**TOWER 2, LEVEL 23
DARLING PARK, 201 SUSSEX ST
SYDNEY NSW 2000**

PROPOSED MIDDLE HARBOUR ROAD HERITAGE CONSERVATION AREA, LINDFIELD: PEER REVIEW

1599 – THE MIDDLE HARBOUR ROAD, LINDFIELD HERITAGE CONSERVATION AREA – REVIEW

APPENDIX 5 - MIDDLE HARBOUR ROAD, LINDFIELD HCA REVIEW – REVISION - JUNE 2016
HCA REVIEW CONTRIBUTION MAP

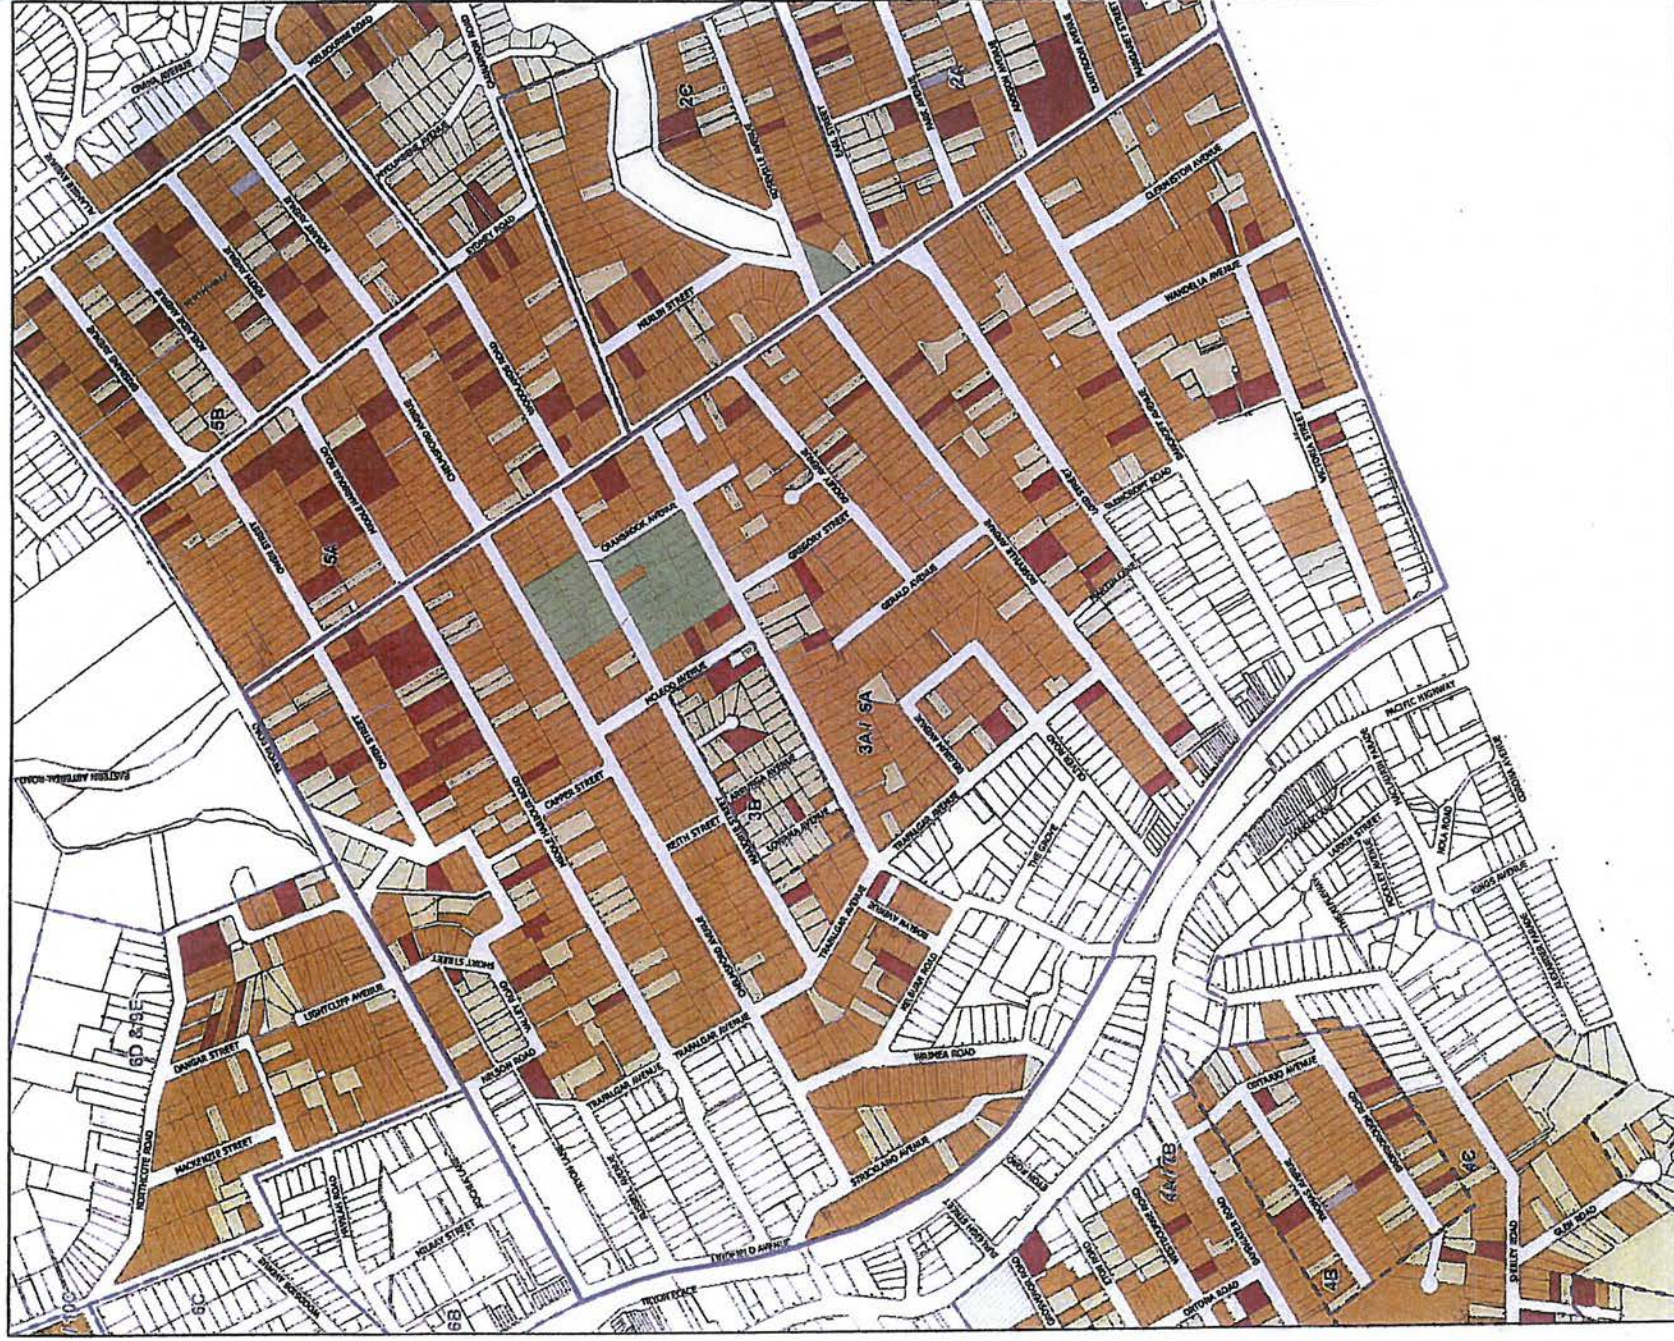
The Middle Harbour Road, Lindfield HCA Review – Revision – June 2016 highlights one detracting property in the proposed HCA, at 1 Howard Street. A physical inspection identified a minimum of 46 detracting properties in the proposed HCA or 22% of properties are detracting. Refer to Appendix 9 – List of Detracting Properties.

- Council's Middle Harbour Road, Lindfield HCA Review – Revision – June 2016 contribution map submitted to the Department of Planning and Environment only highlights 1 detracting property in the proposed HCA, at 1 Howard Street. A 2017 physical inspection, in addition to the Architectural Projects Review 2010 and 2015 identified 46 Detracting Properties in the proposed HCA or 22% of properties are detracting. Refer to Appendix 9 – List of Detracting Properties.

Appendix 10 - 2017 Architectural Projects Review of 19 Buildings classified as 'Contributory' by PMA 2015 Review and Ku-ring-gai Council Review

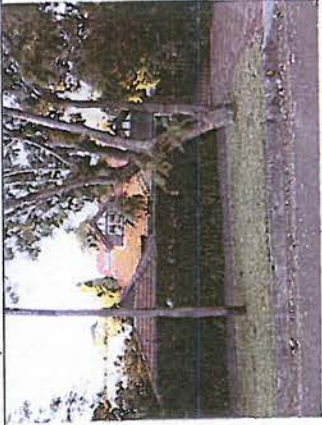
9 Short Street	Contributory	Neutral • External house is completely rendered • Large prominent Double garage at building line. • Proportion of original house shift to horizontal changing typology.
 43 Tryon Road	Contributory	Neutral • Flat roofline extension towards street • New additional fill-in on right side of house • Painted brick
 61 Tryon Road	Contributory	Neutral • Bricks have been rendered • Not original windows • Roofline has changed, • No original gable
 63 Tryon Road	Contributory	Neutral / Detracting • House has been extended towards the street • Large front gable, not original • Full windows and sliding door running width of house • Painted brick • New railing
 73 Tryon Road	Contributory	Neutral • Inter-war • Large additional window at front right • Highlight windows added to 2nd storey above window

Appendix 10 - 2017 Architectural Projects Review of 19 Buildings classified as 'Contributory' by PMA 2015 Review and Ku-ring-gai Council Review

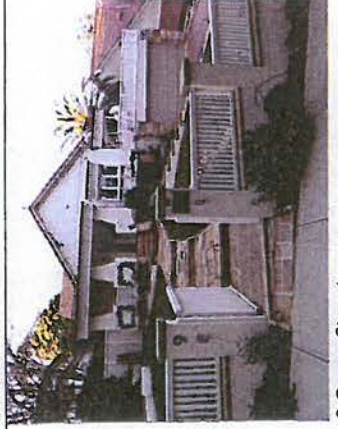
2A Owen Street	Contributory	Neutral • Inter-war. • Dominant double garage plus second storey addition to right of house built one foot behind building line. • Changes proportion of the house.
 9 Owen Street	Contributory	Neutral • Dominant double garage 2m forward of building line • Extended verandah above double garage • Proportion of original house shift to horizontal
 91 Middle Harbour Road	Contributory	Neutral • Large dominant carport 100% forward of the building line • Rendered brick • Conceals original house
 89 Middle Harbour Road	Contributory	Neutral • New Garage under house • Change proportion • Rendered brick
 73 Middle Harbour Road	Contributory (Borderline)	Neutral • Painted Brick • Dominant double carport 100% forward of building line. • Original building concealed

Appendix 10 - 2017 Architectural Projects Review of 19 Buildings classified as 'Contributory' by PMA 2015 Review and Ku-ring-gai Council Review

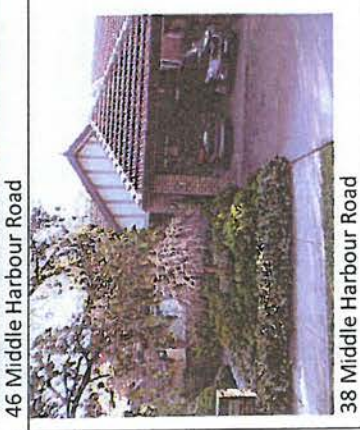
Contributory	Neutral • Painted brick • Dominant and visible 2nd storey addition to a single level federation • Chang proportions
67 Middle Harbour Road 	Contributory	Neutral • Carport structure 100% forward of building line • Painted brick • Has planning approval for demolition since 2014
52 Middle Harbour Road 	Contributory	Neutral • Painted brick • Verandah extended around house • Railing not original • Added triple garage, highly visible despite setback from the forward building line
46 Middle Harbour Road 	Contributory	Neutral • Attached carport to roofline and building • 100% forward of building line • Amended Verandah • Amended gable support • Carport Dominant structure • Original building concealed
38 Middle Harbour Road
